Access Compliance Report Public Rights-of-Way (Curb Ramps)

Main Street: ARROYO_AVE Cross Street: CASTLEGATE_LN Location: W

ADA ID: RPRK211011105810 Ramp Type: Type 1 - Perpendicular Diagonal Initial Pass/Fail: Fail Overall Compliance: No Severity Score: 16

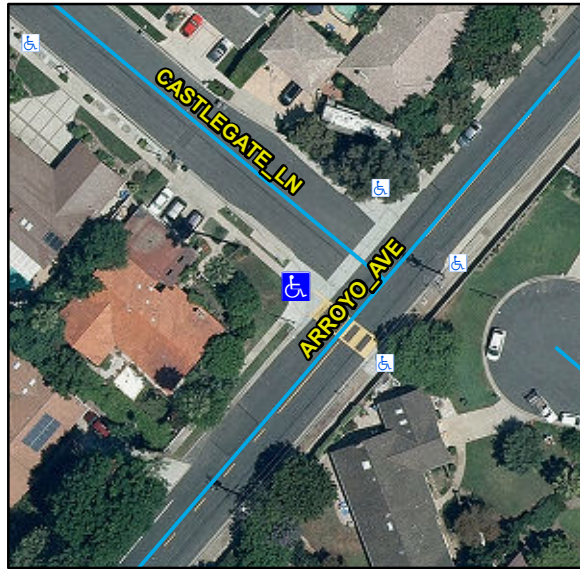
R304.2.2, R304.5.3, STD 1115

Remove & Replace Curb Ramp With Two New Directional Ramps or Equivalent.
